OPTIONAL SERVICE BULLETIN

OSB 42-124

OSB 42NG-062

Retrofit installation of single piece heater valve bowden cable and alternate air valve bowden cable.

Mark the position for the new bowden cable bracket according figure below.

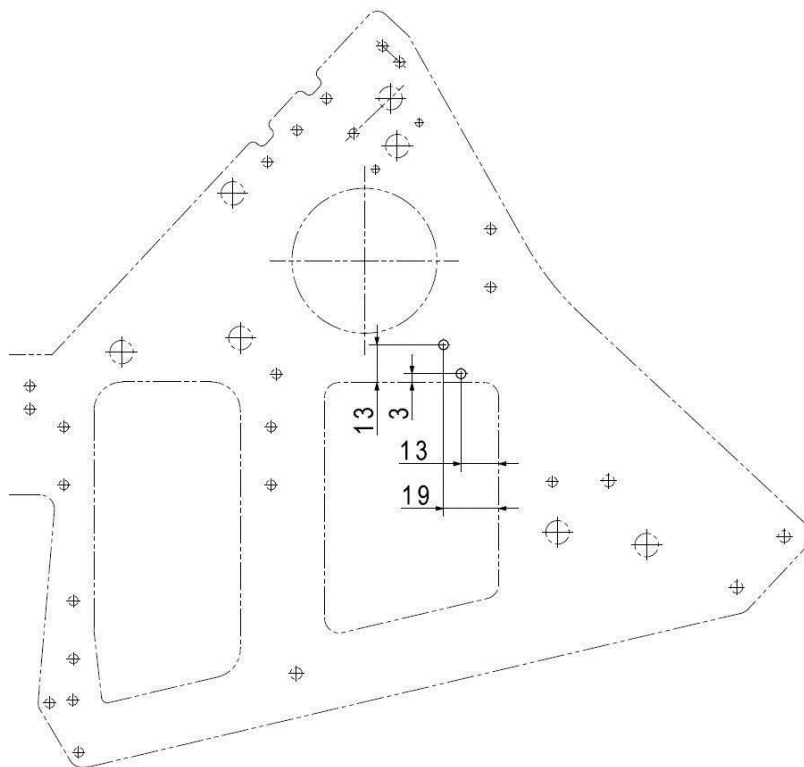
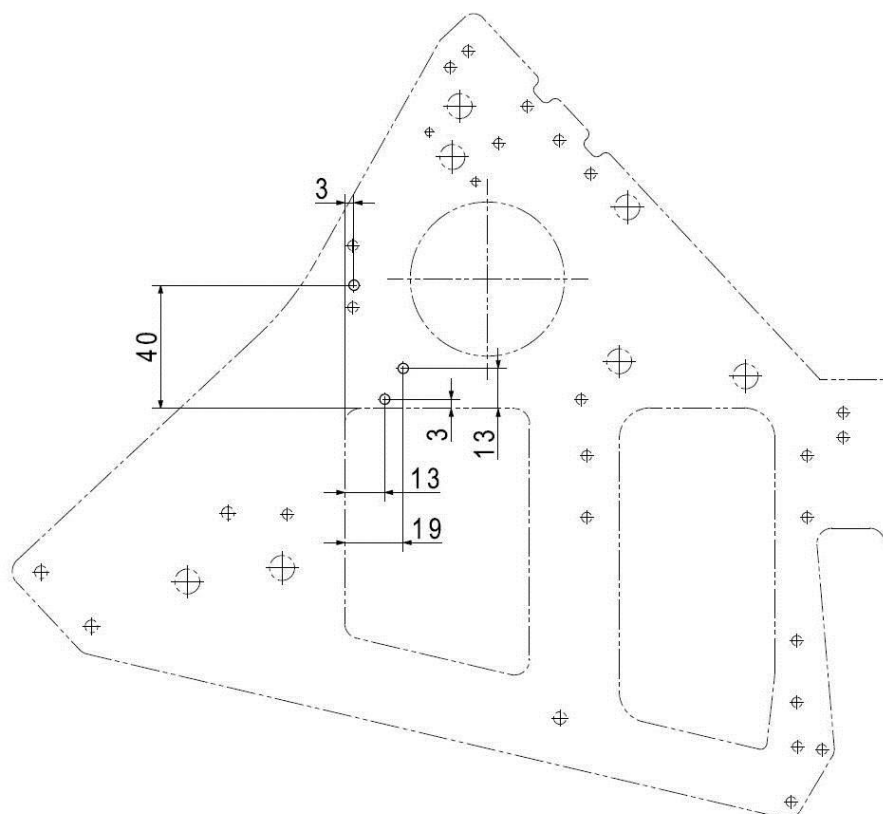
Drill out the rivets from the old bowden cable bracket in the engine control assy and discard bracket.

26	Drill holes for new bowden cable bracket on marked position.
27	Position the new bowden cable bracket D67-7613-11-08 and install it with rivets DIN7337A-3,2x6,7-A2.
28	Remove the axle from the heating-, defrost and brake lever.
29	Reassemble the axle with new heating and defrost levers D67-7163-02-00 i.a.w. drawing D64-7613-10-00_04 page 2 Section B-B. Note: Take care of correct reassembly sequence of bushings and washers.
30	Guide bowden cables through the center console to their final installation position.
31	Connect the alternate air bowden cables to the alternate air lever.
32	Reinstall the engine control assy and connect new heating and defrost bowden cable.
33	Make sure that all bowden cables are adjusted and for function properly.
34	Attach bowden cables with cable ties where necessary.
35	Install the LH unfeathering accumulator to the engine mount.
36	Install the RH charged air hose between turbo charger and intercooler.

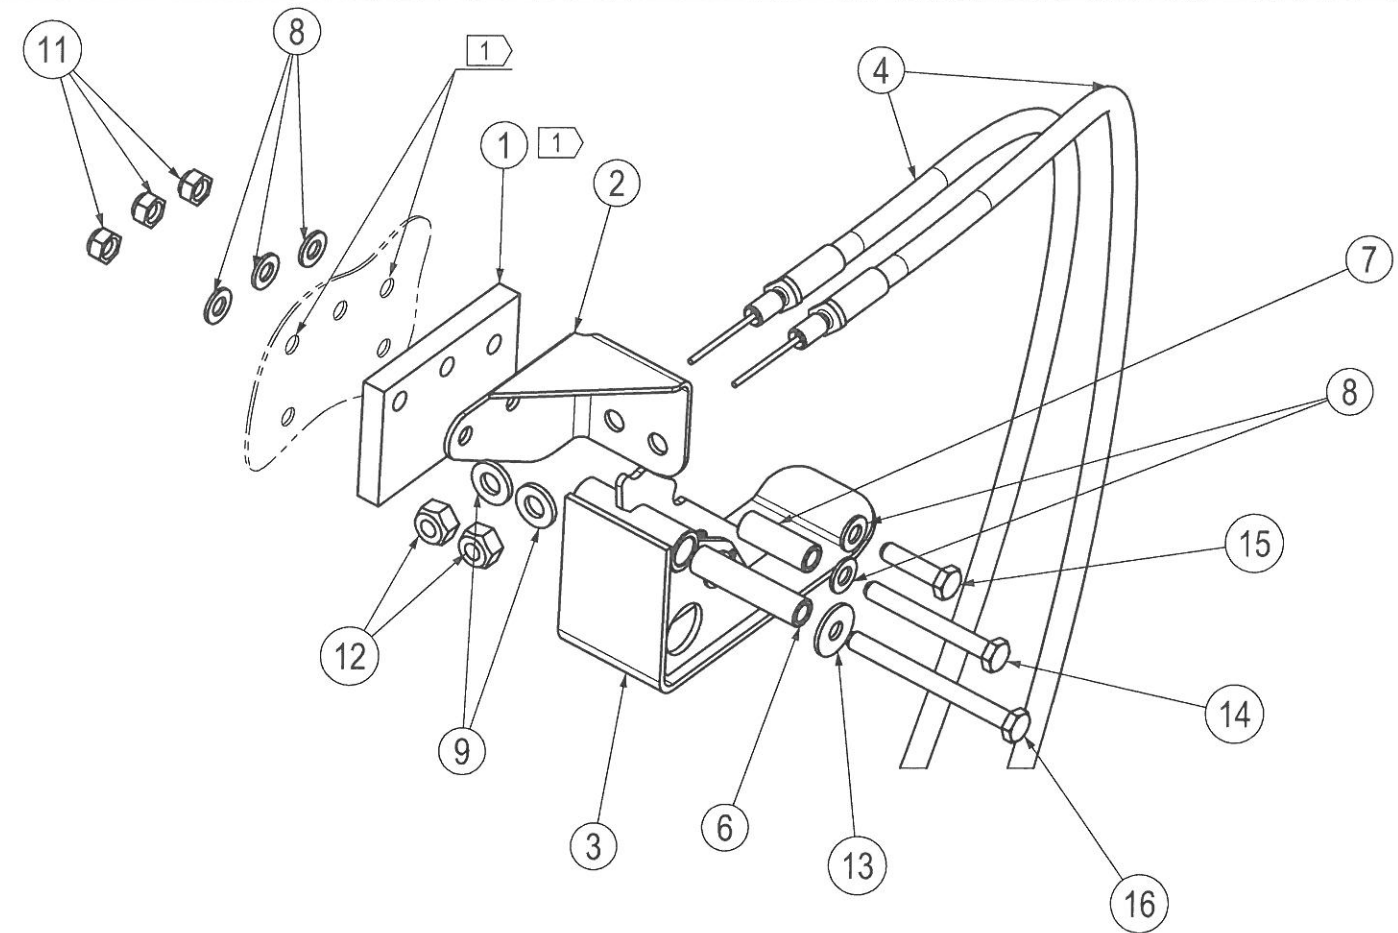
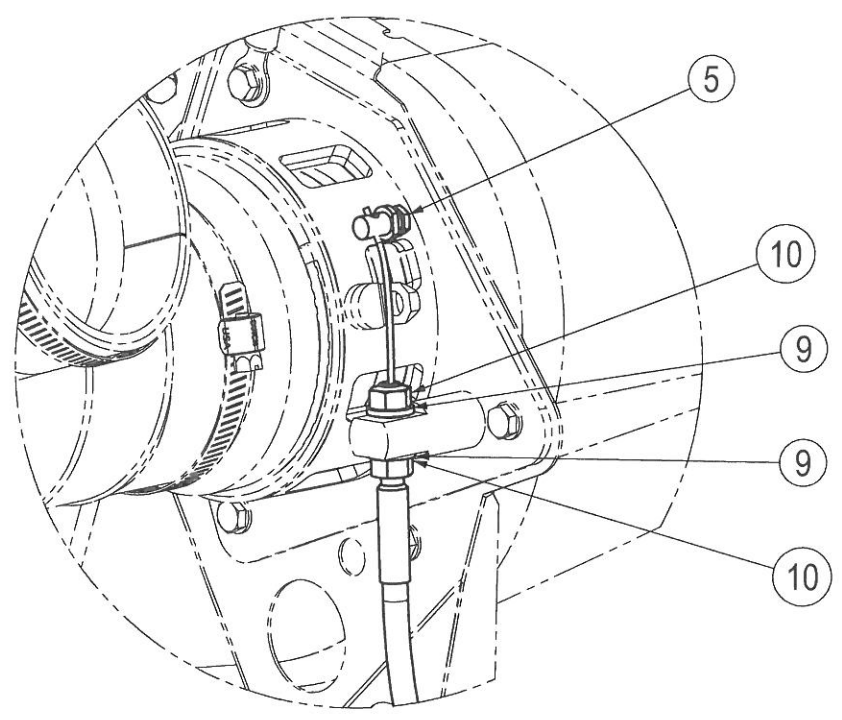
23	Install alternate air control lever i.a.w. drawing D64-7103-00-00_01. Adapt glas insert plate and center console to new hole pattern i.a.w. alternate air bowden cable bracket D67-7163-00-04.

REVISION				
REV	SH	ZONE	DESCRIPTION	DATE
-	01	ALL	MÄM 42-933 NEW DRAWING, SUPERSEDES D64-7103-00-00; DA 62 DESIGN IMPLEMENTED.	24.02.16

1 DRILL HOLES ACCORDING TO ITEM 1, Ø 5,5mm
